# PARKSIDE P.R.U.D. PHASE 1

# THE BRIDGES - PHASE 1

## PRELIMINARY CONSTRUCTION DOCUMENTS EDEN, WEBER COUNTY , UTAH

Drain outlet Pond 2

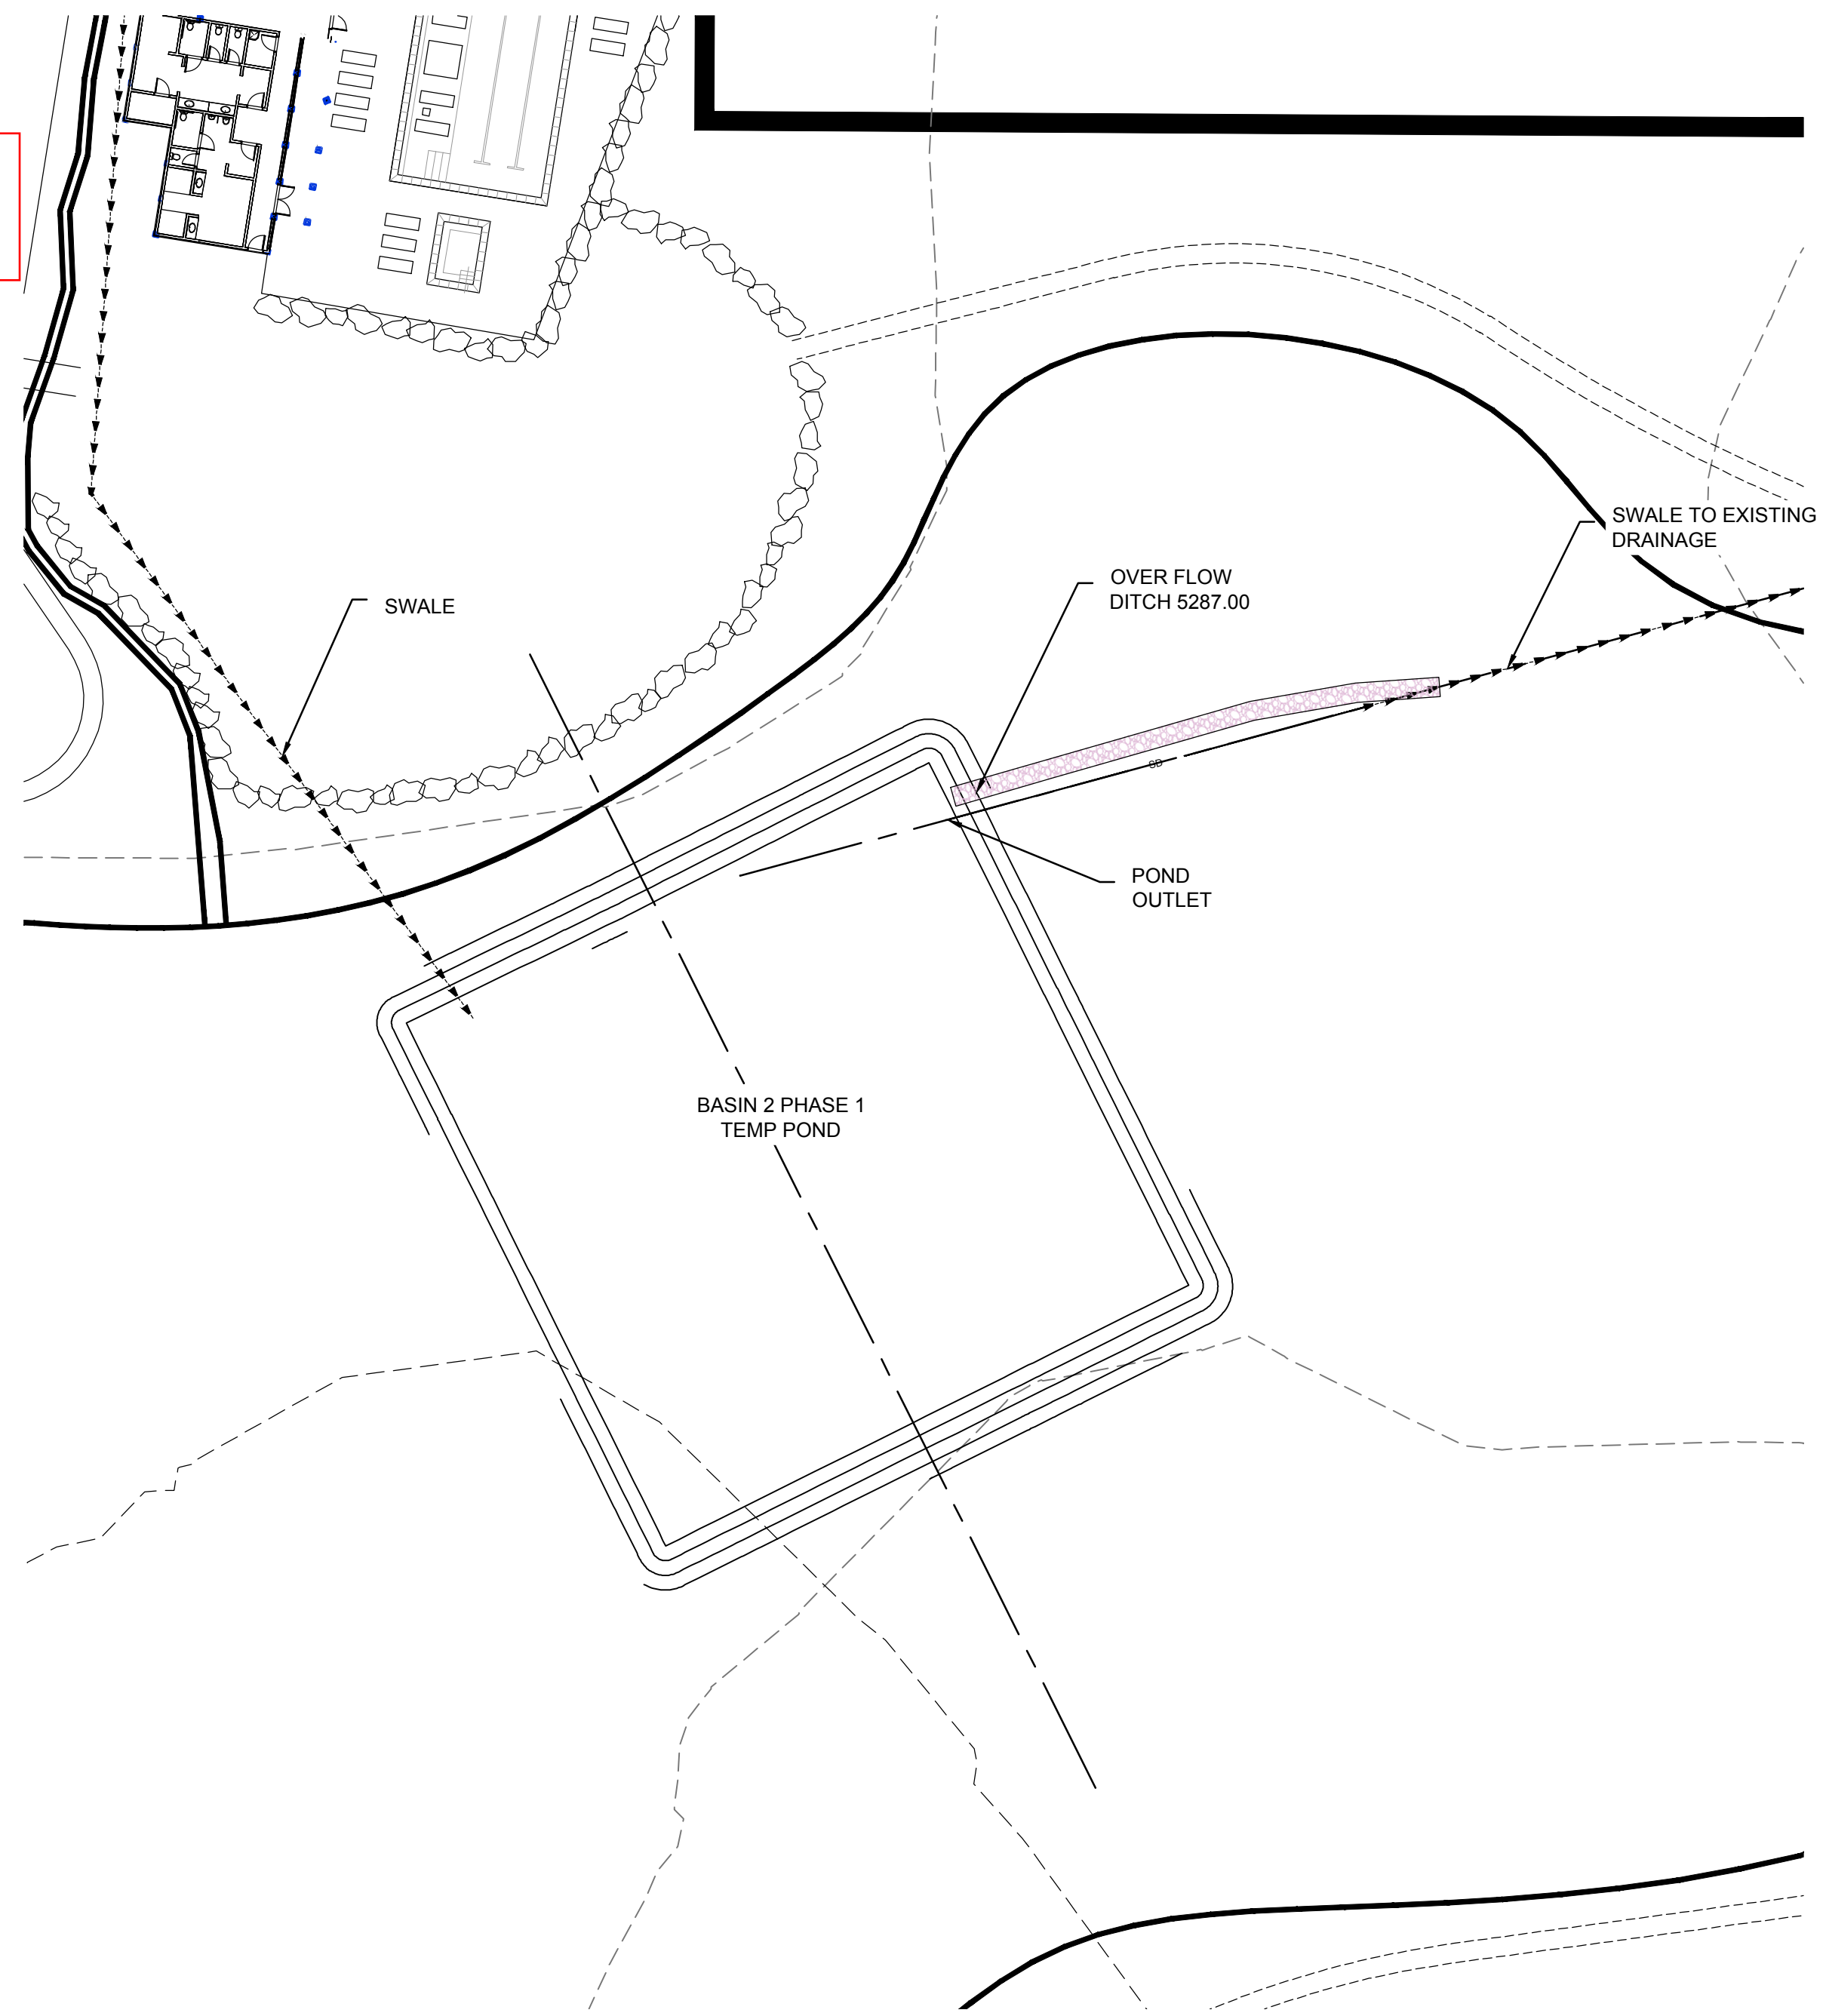
Is just the pond and swale being installed within this area?

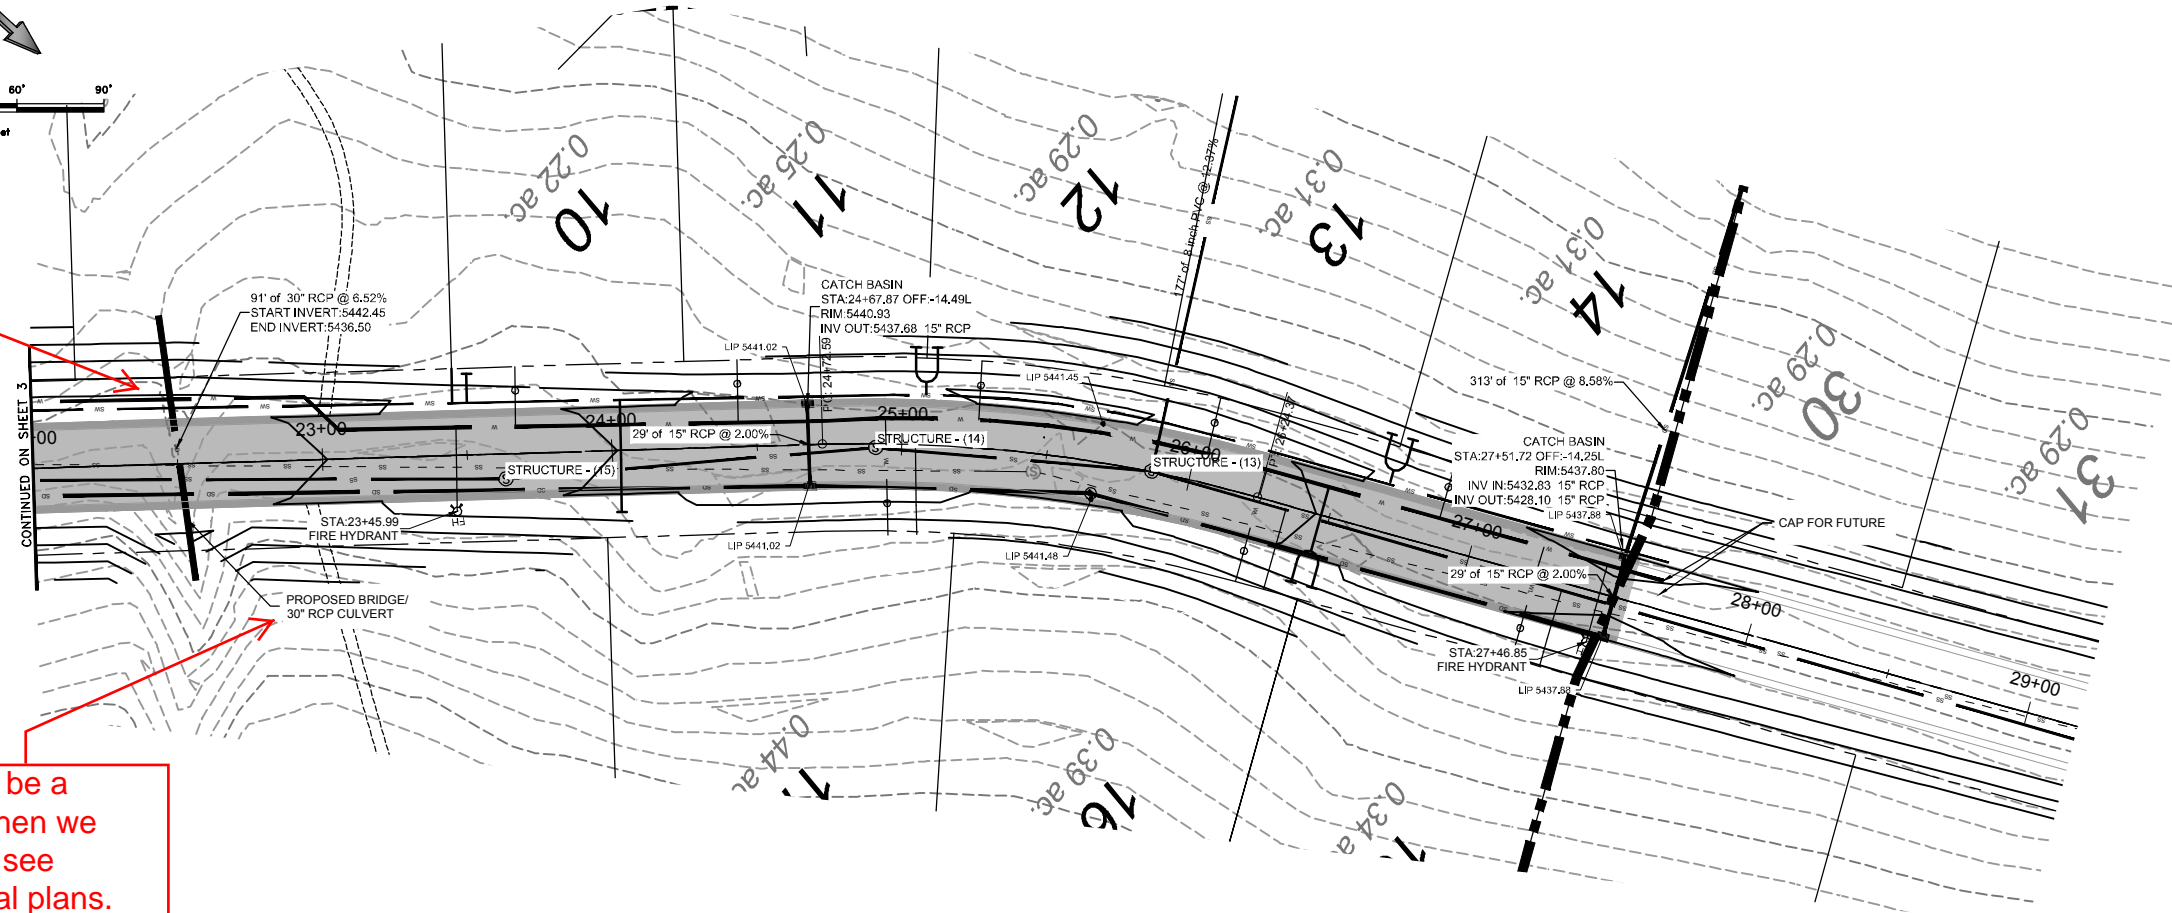
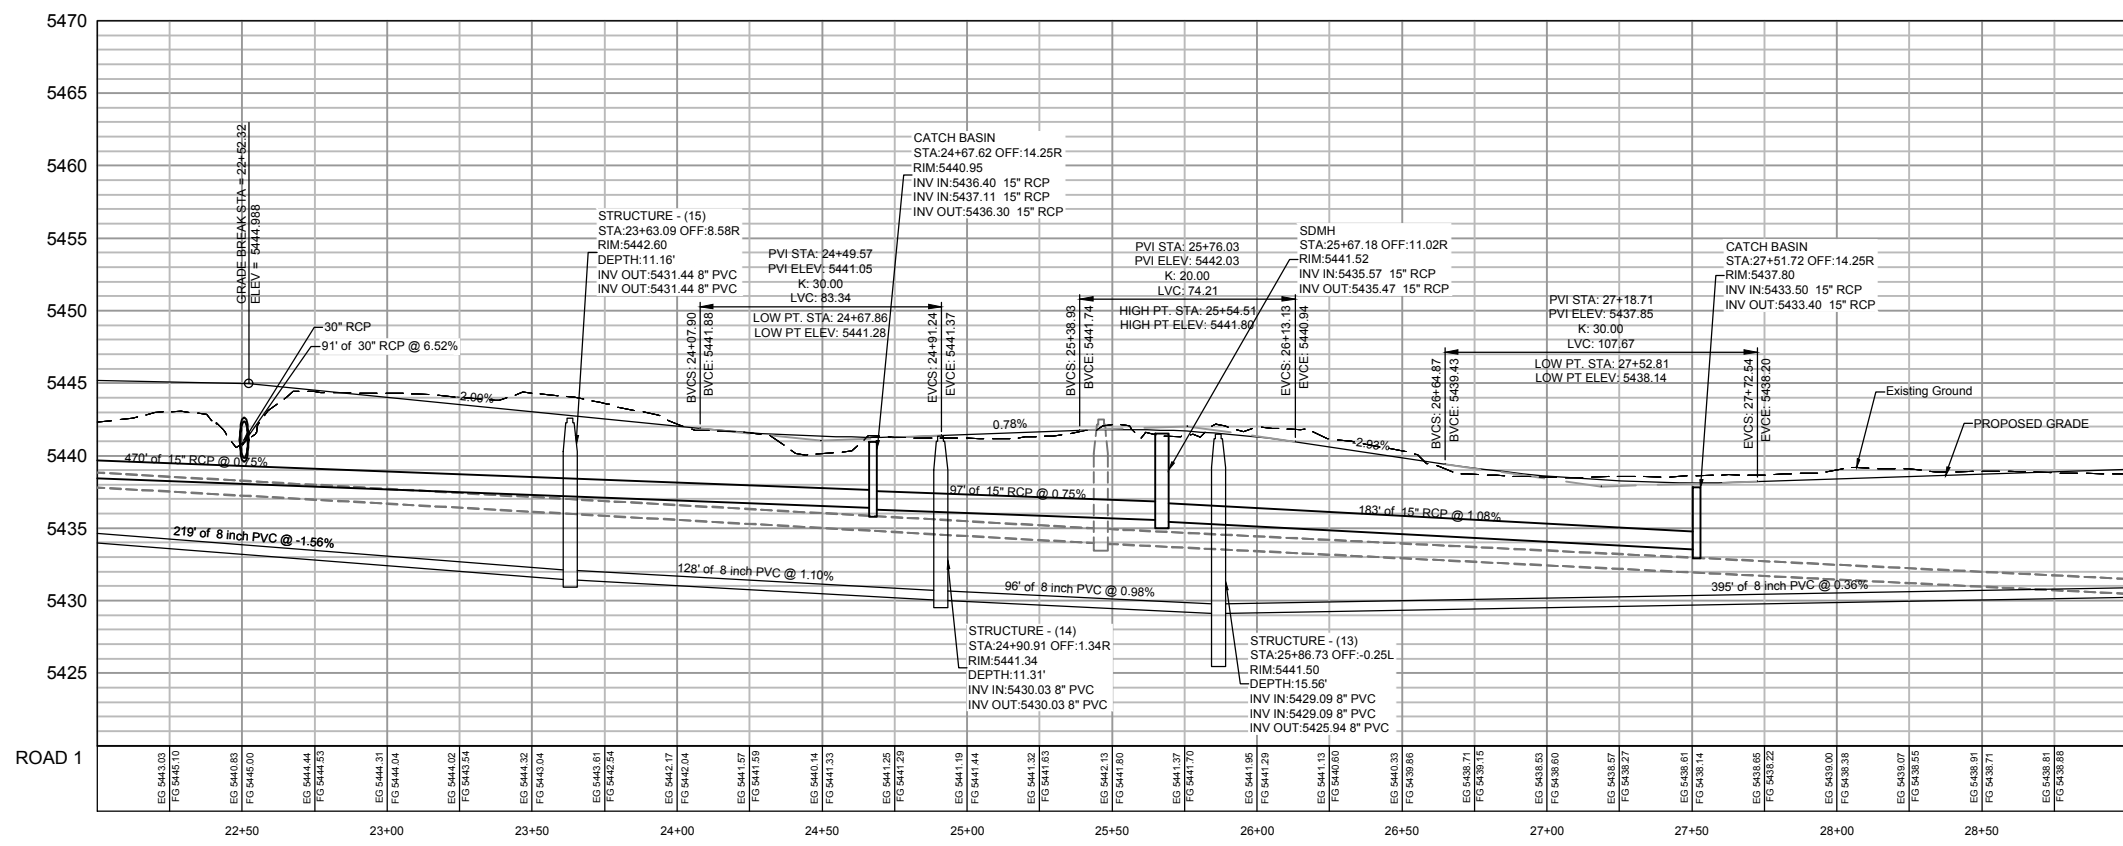
Are there calculations for the sizing of this culvert?

If it is to be a bridge then we need to see structural plans.

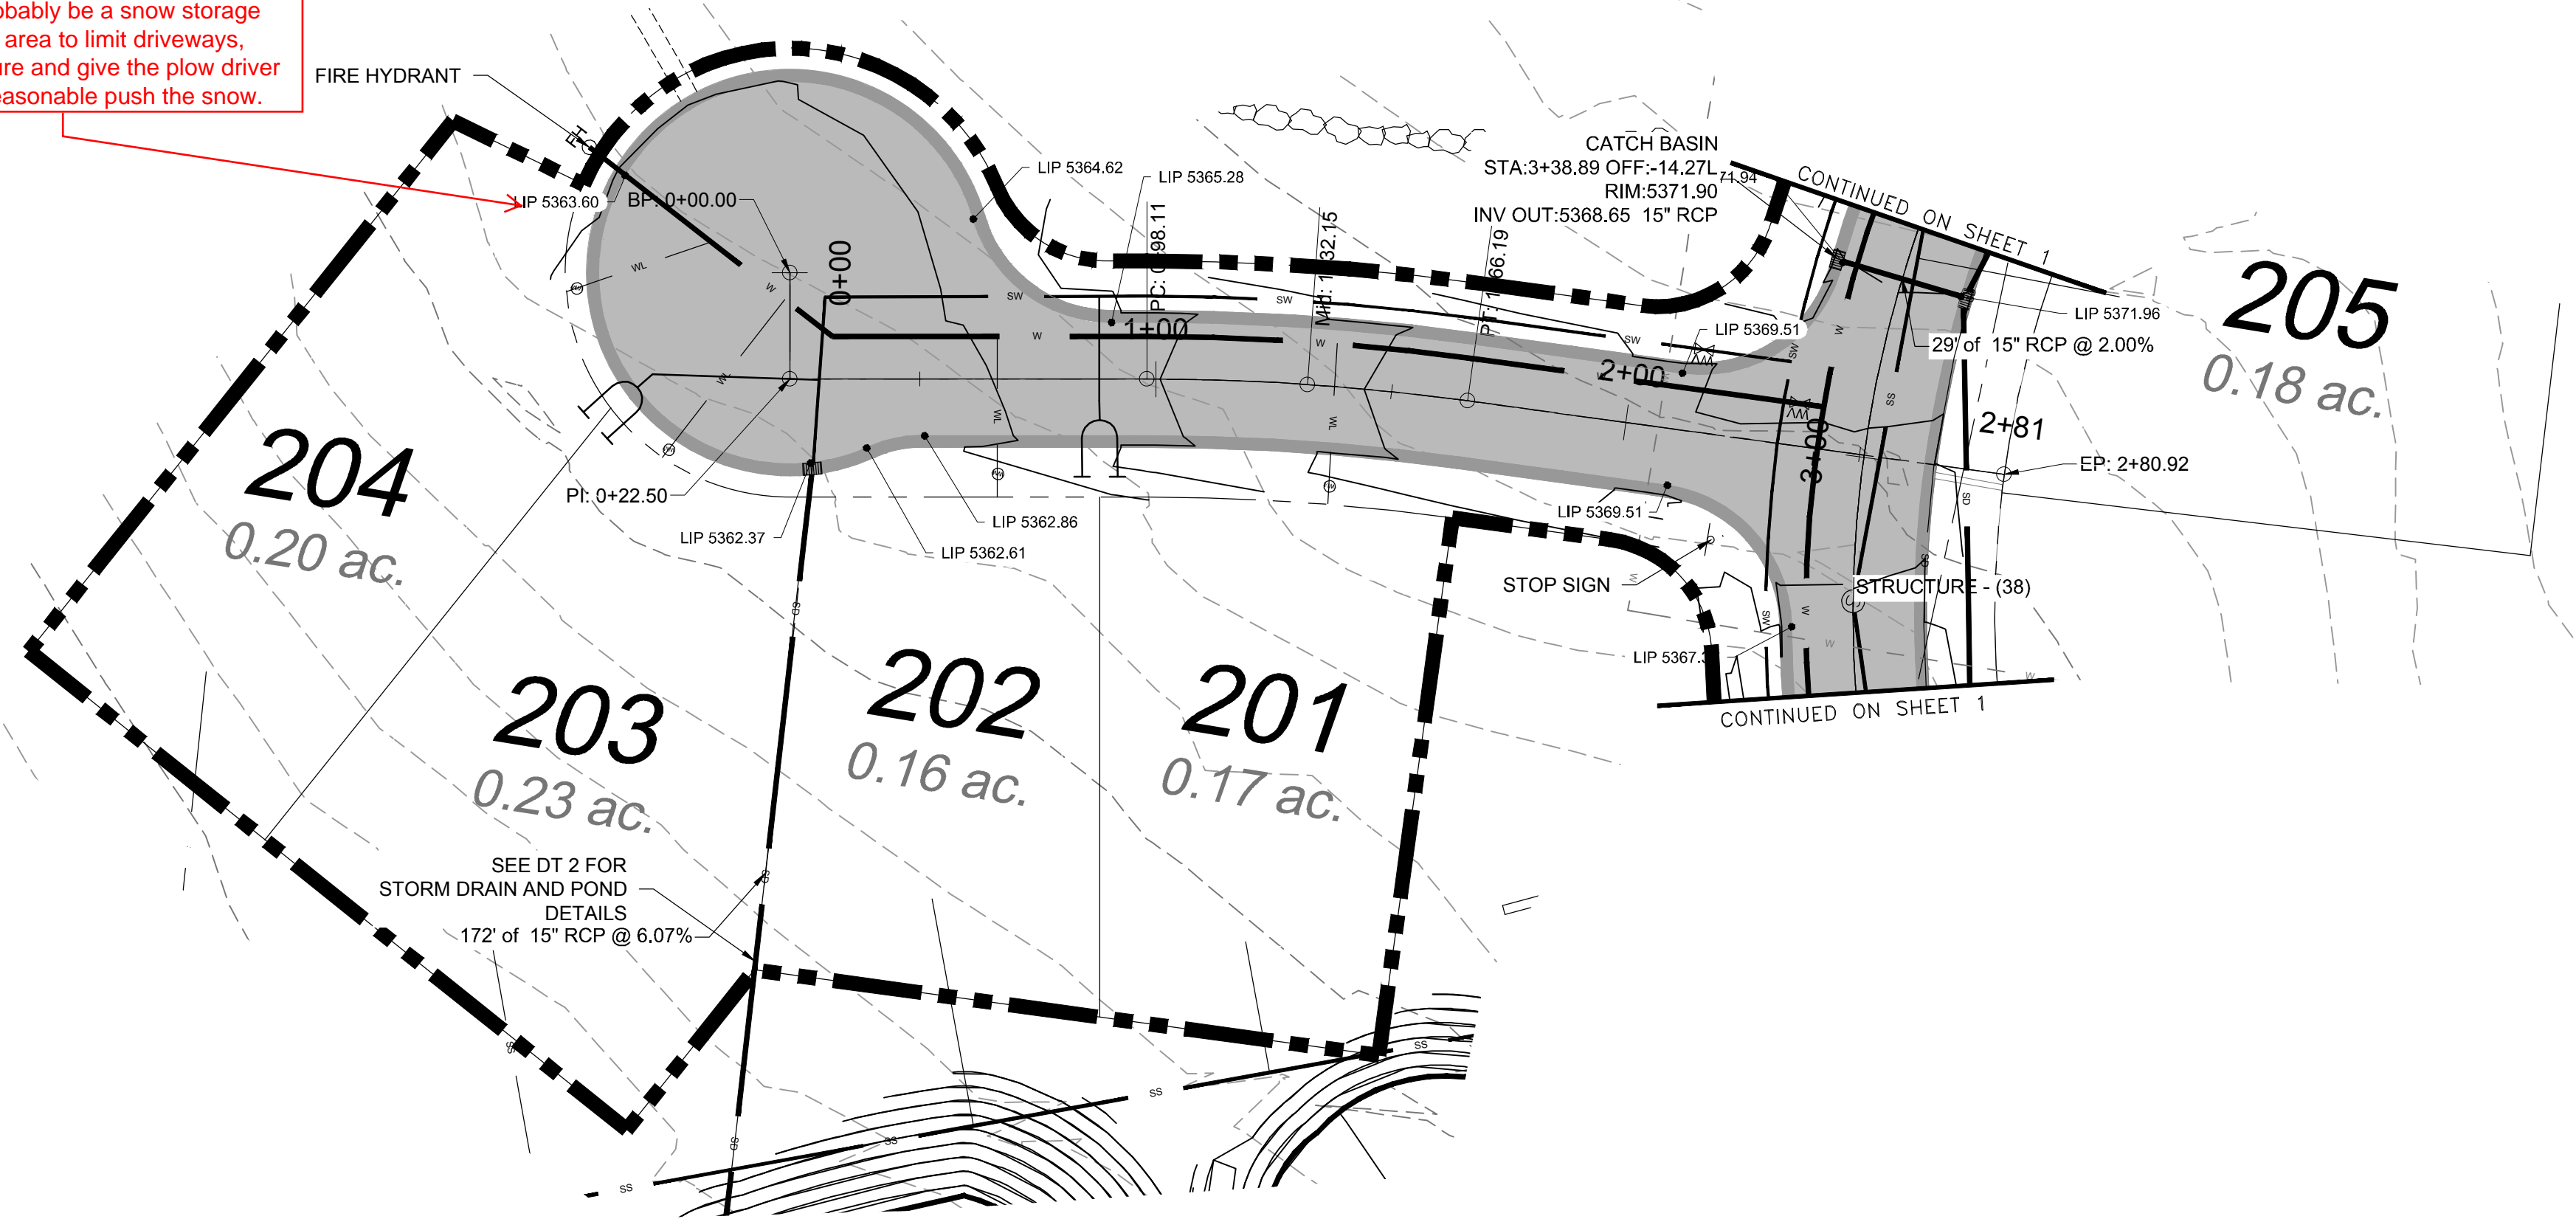
There should probably be a snow storage easement in this area to limit driveways, utility infrastructure and give the plow driver somewhere to reasonable push the snow.
